UZBEKISTAN GAS TO LIQUID PROJECT (UZGTL)

HAZOP ACTION CLOSE-OUT REGISTER FOR MAKE-UP H2 COMPRESSOR PACKAGE

UZGTL-HDC-HSE-RP-50-0-0004

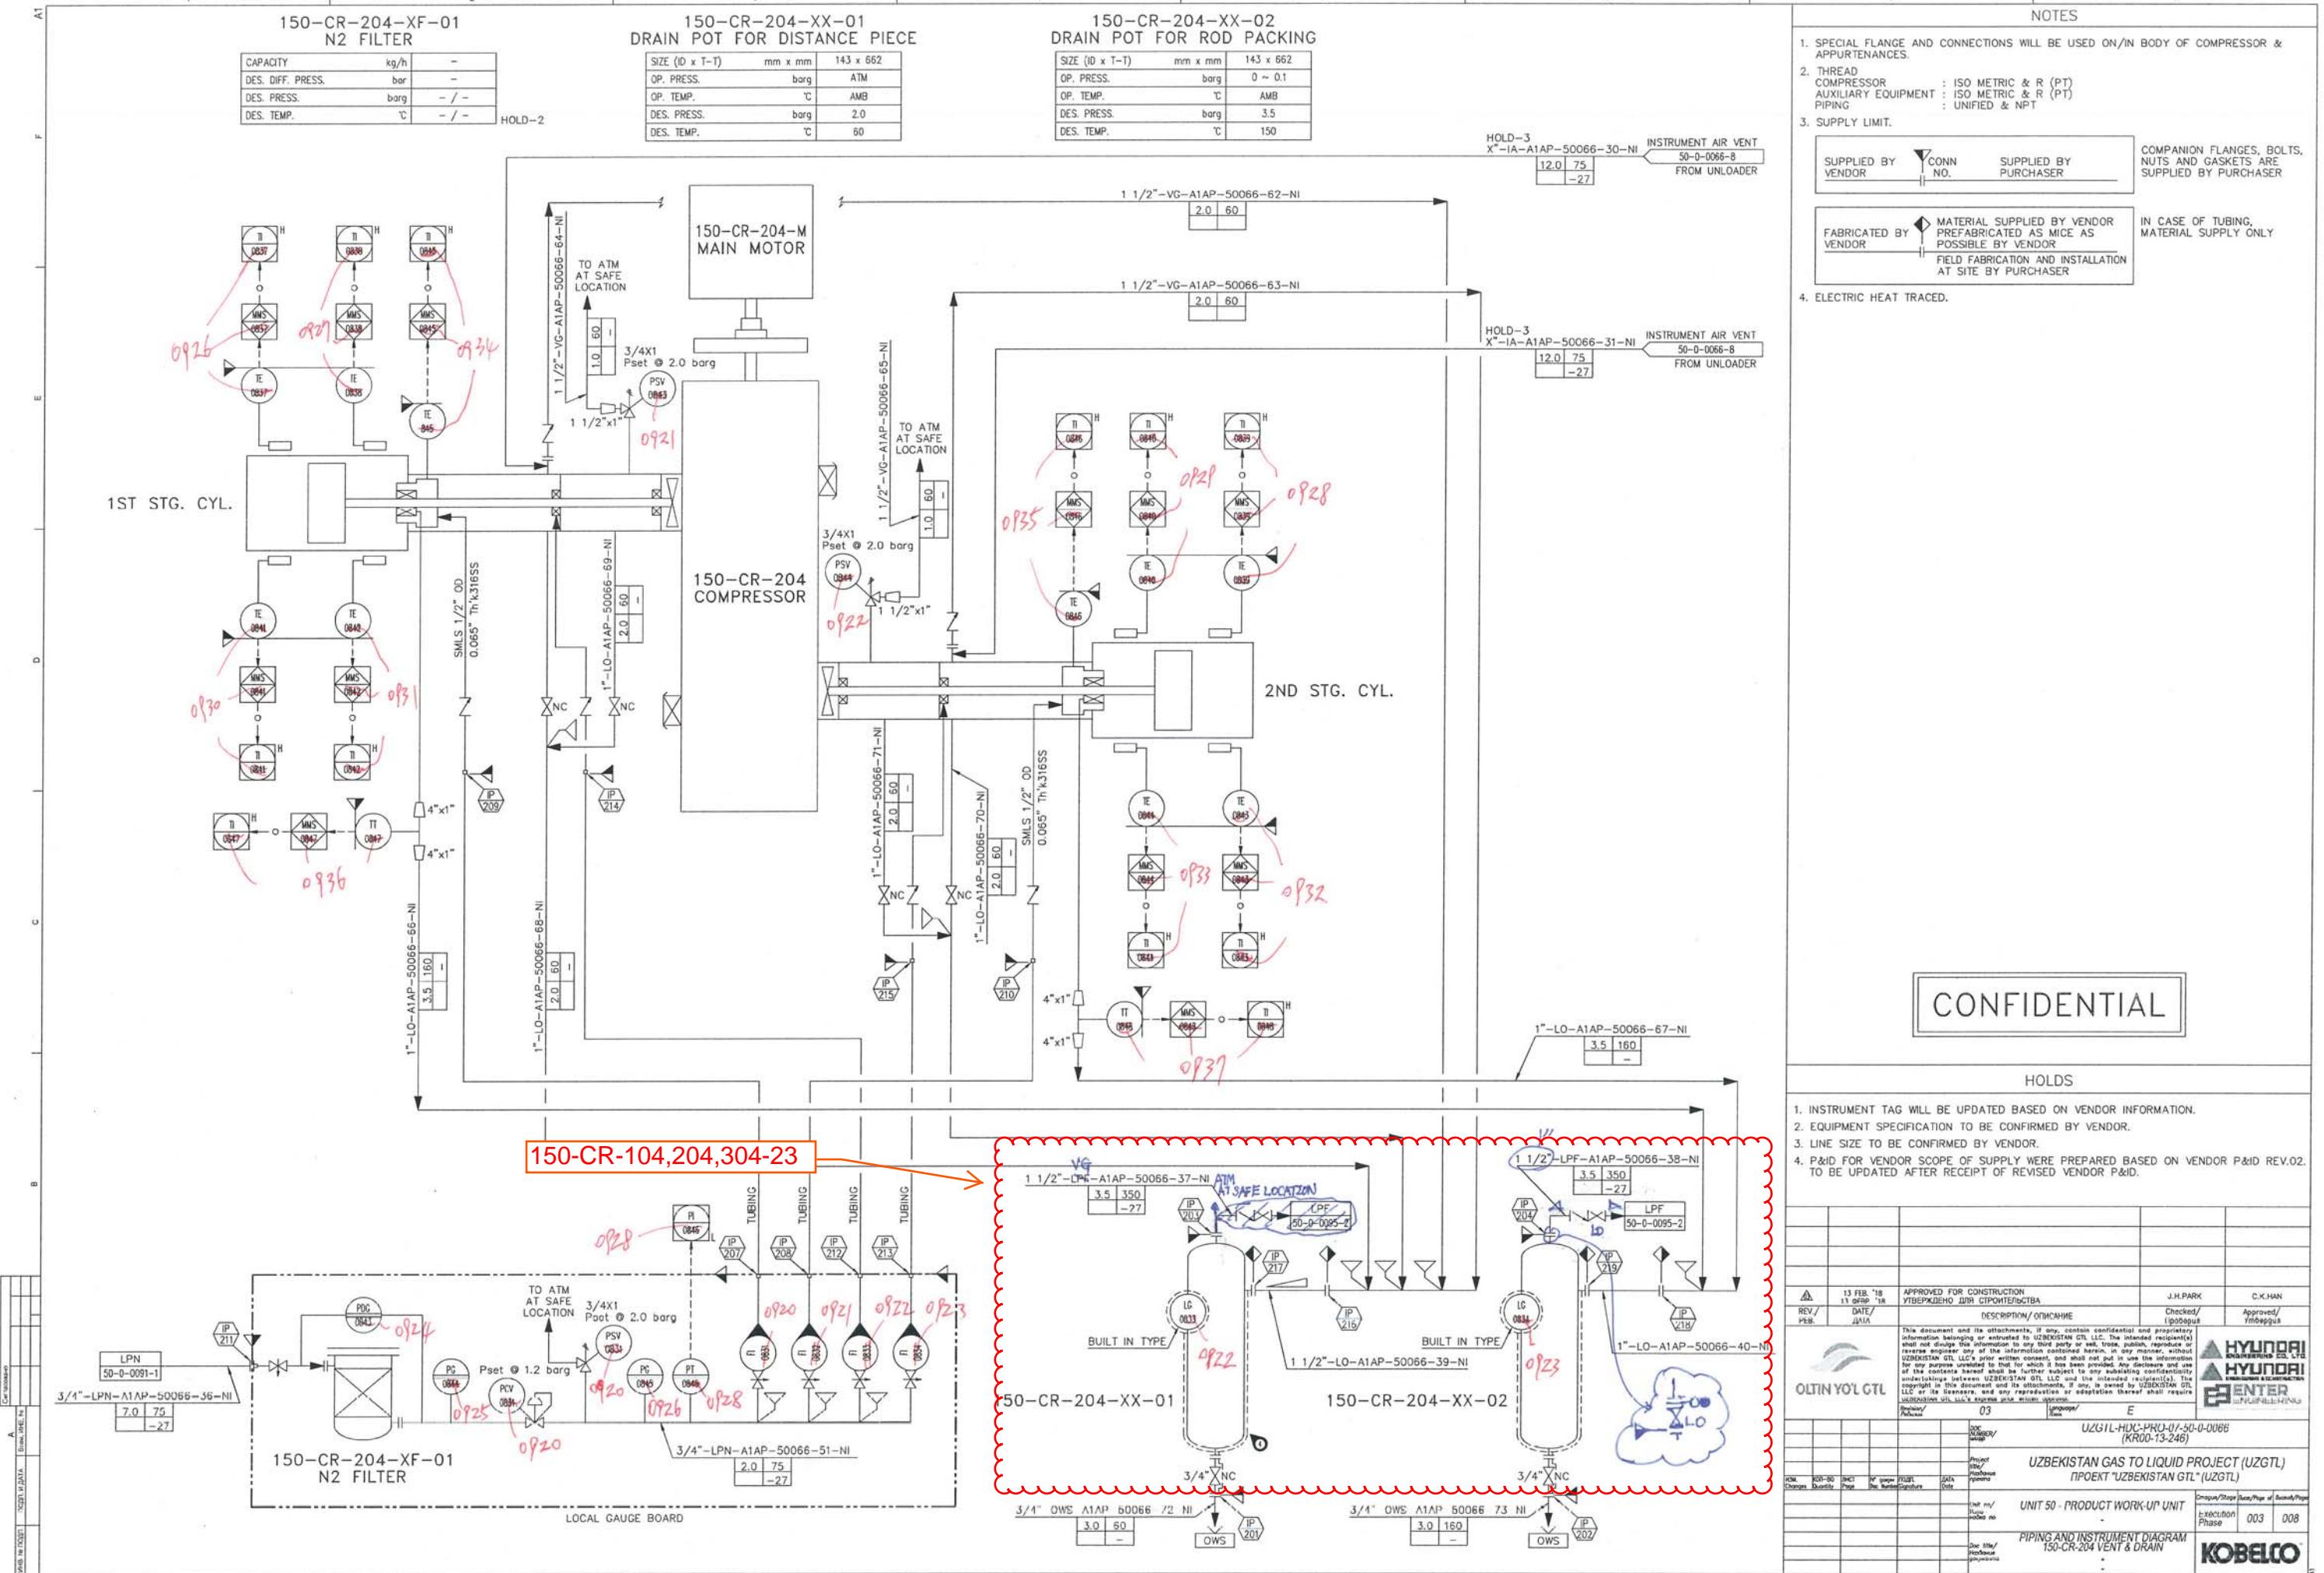
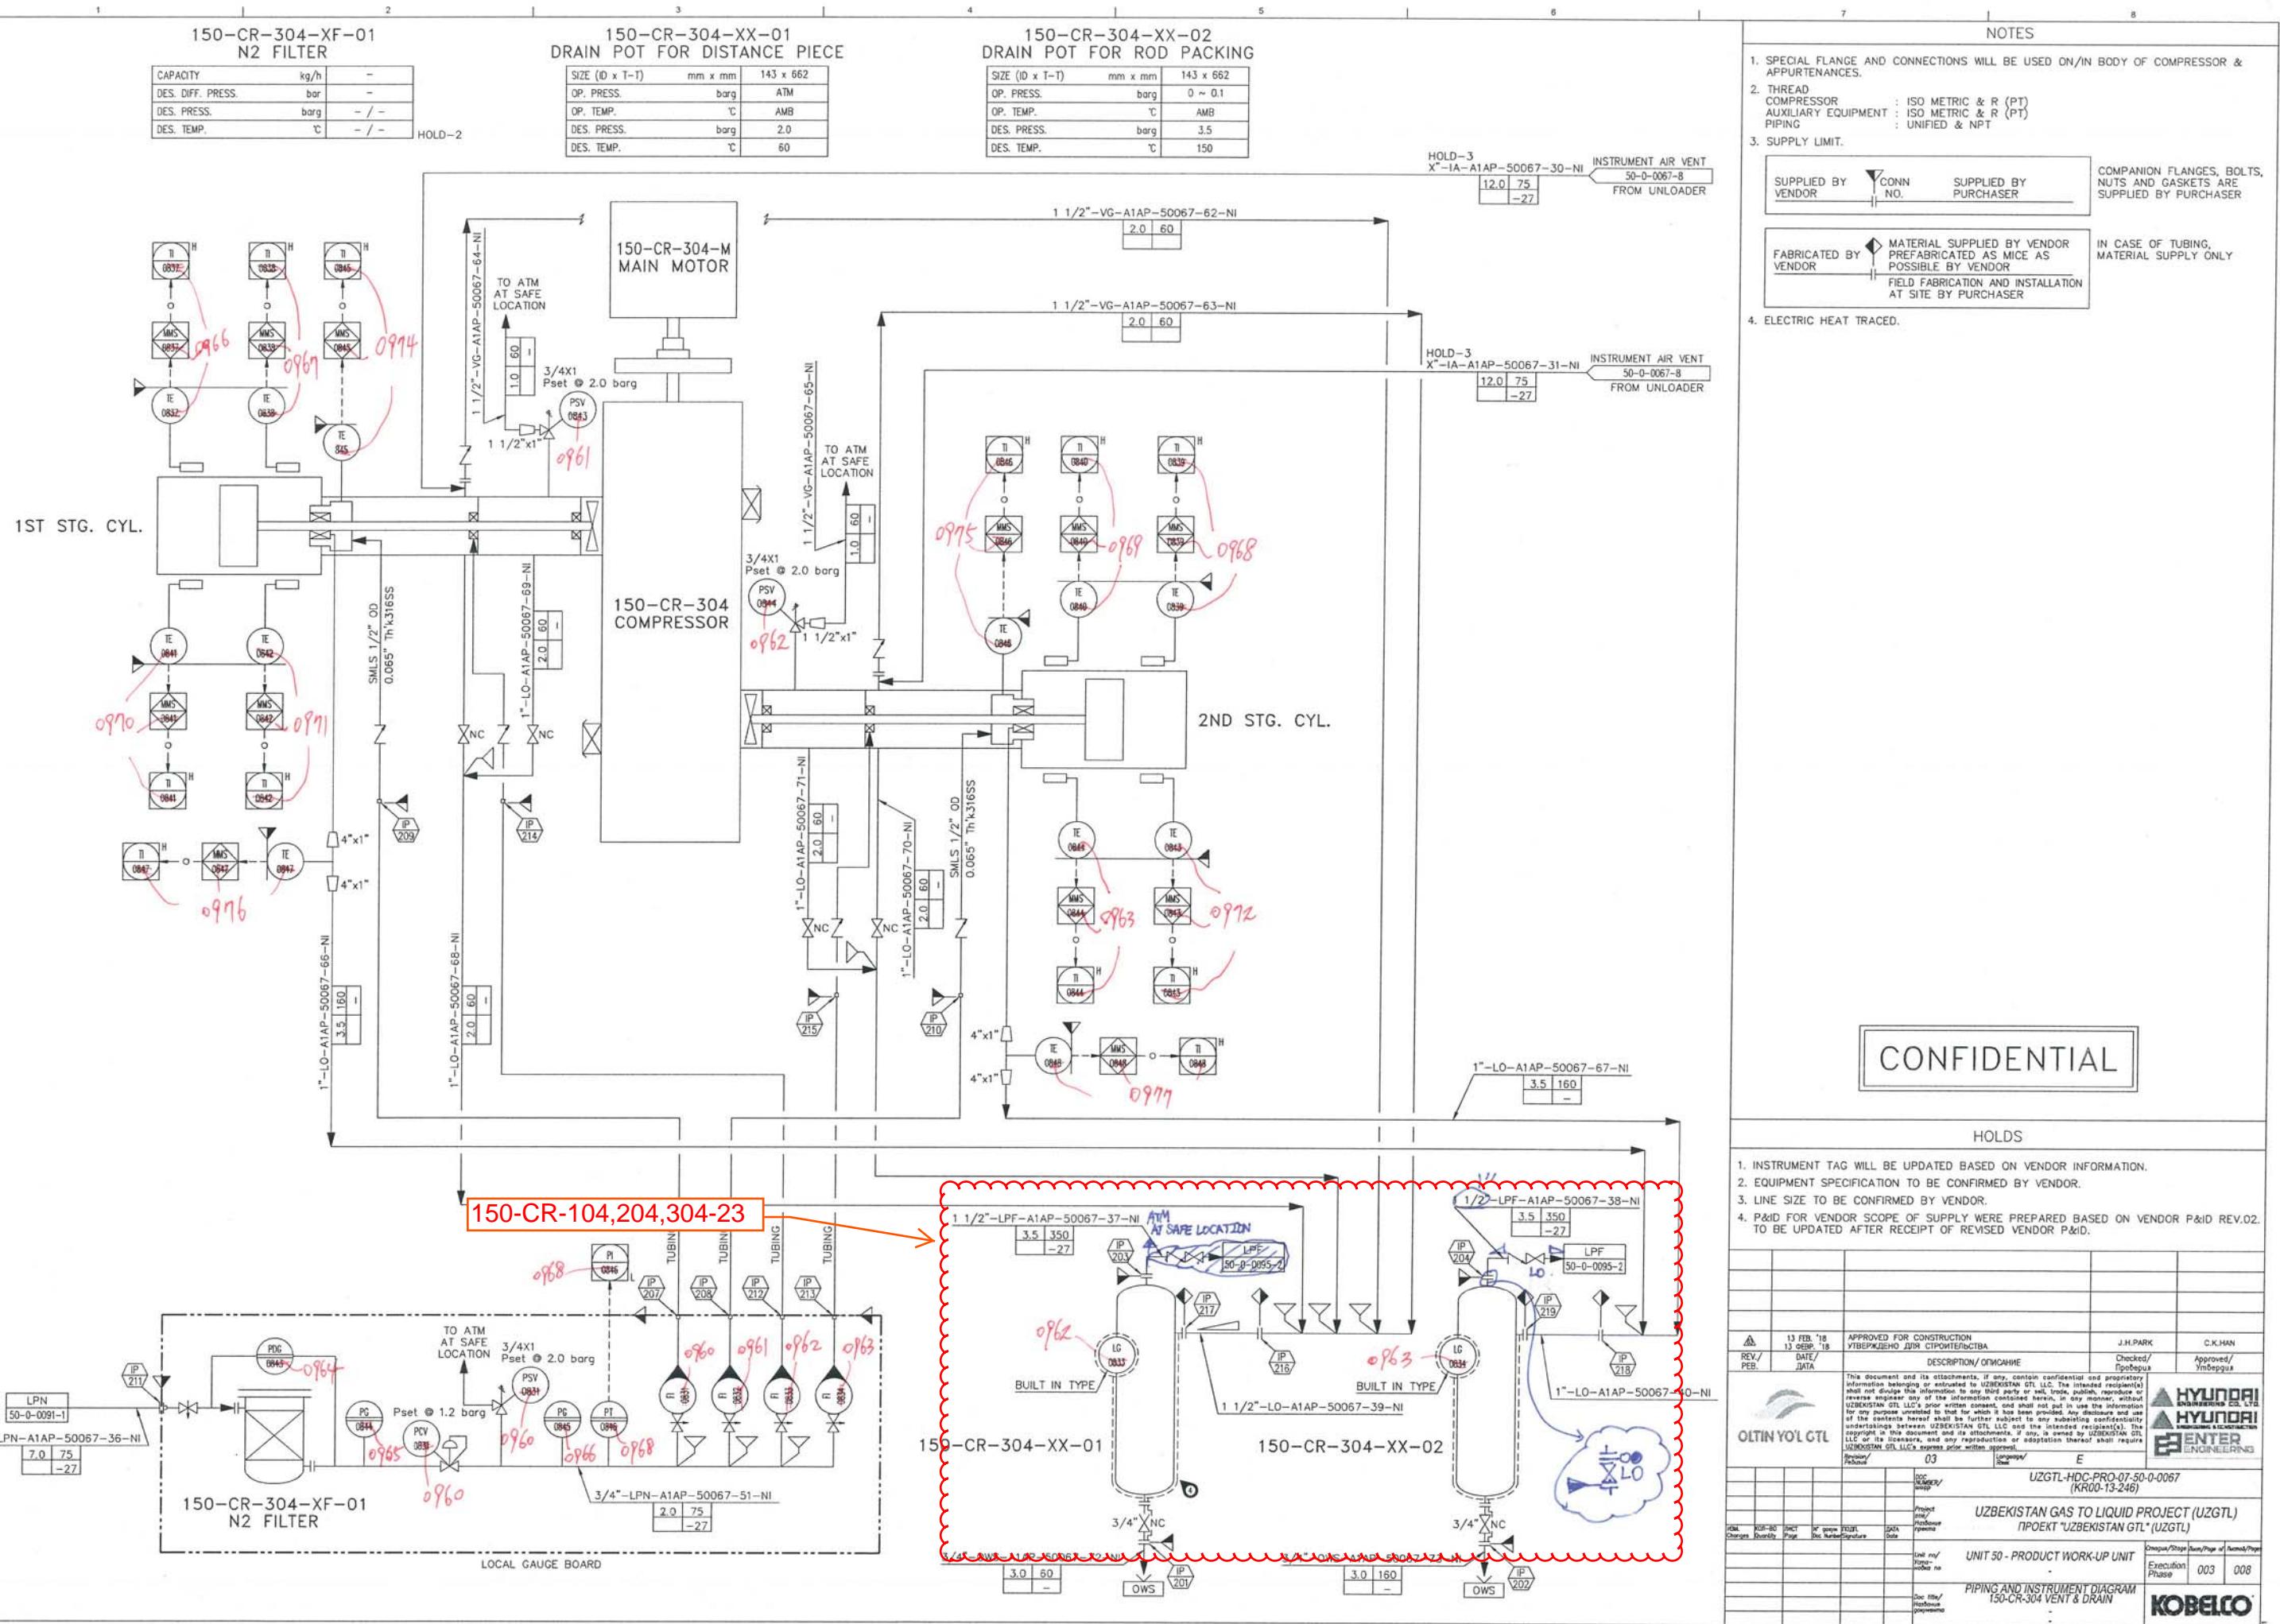
Action No.	150-CR-104/204/304-23				
Action By	PR				
Node No.	1				
Node Description	1. Compressor Process Gas / Compressor Vent & Drain / Compressor Unloader				
Cause	1.3.6. Reverse Flow of flammable gas from flare into Drain Pot 150-CR-104-XX-01 1.3.7. Reverse Flow of flammable gas from flare into Drain Pot 150-CR-104-XX-02				
Consequence					
Safeguards	1.3.6.1.1. Check valve on Drain Pot 150-CR-104-XX-01 vent 1.3.7.1.1. Check valve on Drain Pot 150-CR-104-XX-02 vent				
Action	Provide manual valve (LO) downstream of check valve on Drain Pot 150-CR-104-XX-01/02 vent line

Response	The vendor confirmed that both lines of the 150-CR-104-XX-01/02 could be released to ATM. However, contractor decided to connect the vent line of the Drain Pot for ROD Packing (150-CR-104-XX-02) to the LPF by supplying manual valve (LO). Therefore, the vent line of 150-CR-002-XX-01 will be connected to ATM, and the vent line of 150-CR-002-XX-02 will be connected to LPF by supplying manual valve (LO). (Please refer to attached E-mail and P&ID, UZGTL-HDC-PRO-07-50-0-0065/66/67-3)				
CONTRACTOR			OWNER		
Position	Signature	Date	Position	Signature	Date
Process Engineer	<u>B.M.Hwang</u> 	10-Apr-2018		_____
